Access Compliance Report Public Rights-of-Way (Curb Ramps)

Main Street: KEMPTON_DR Cross Street: CHAUCER_RD Location: NW

ADA ID: RPRK211208123901 Ramp Type: Type 1 - Perpendicular Diagonal Initial Pass/Fail: Pass Overall Compliance: No Severity Score: 19

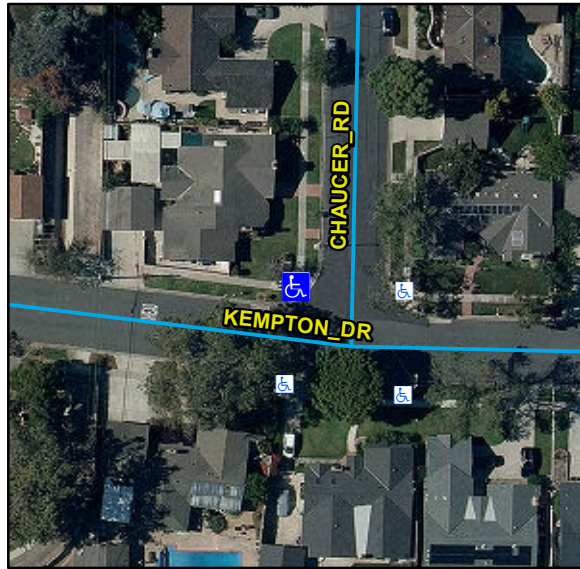
R304.2.2, R204.3, R304.2.1, R305, R302.7.2, R304.5.4, R304.5.3, STD 1115

N/A	Ramp Inside Crosswalk 1	N/A	Yes	Ramp Inside Crosswalk 2	N/A
	Crossing 1 Slope (%)	11.1		Crossing 2 Slope (%)	4.9
	Crossing 1 Cross Slope (%)	3.7		Crossing 2 Cross Slope (%)	3.2
Yes	Gutter Ponding	No	No	Curb Slope	6.8
No	Gutter Lip Height (in)	0.25		Road Run Slope (%)	2.9
No	Gutter Run Slope (%)	14.1		Road Cross Slope (%)	7.2
No	Gutter Cross Slope (%)	4.4			
Yes	Overall Surface Condition: Acceptable		No	Perp Joint Present	No
	Cross Gutter Present?	No		Spandrel Present?	No
	Replace Cross Gutter?	N/A		Replace Spandrel?	N/A

Remove & Replace Curb Ramp With Two New Directional Ramps or Equivalent. Remove & Replace Gutter.
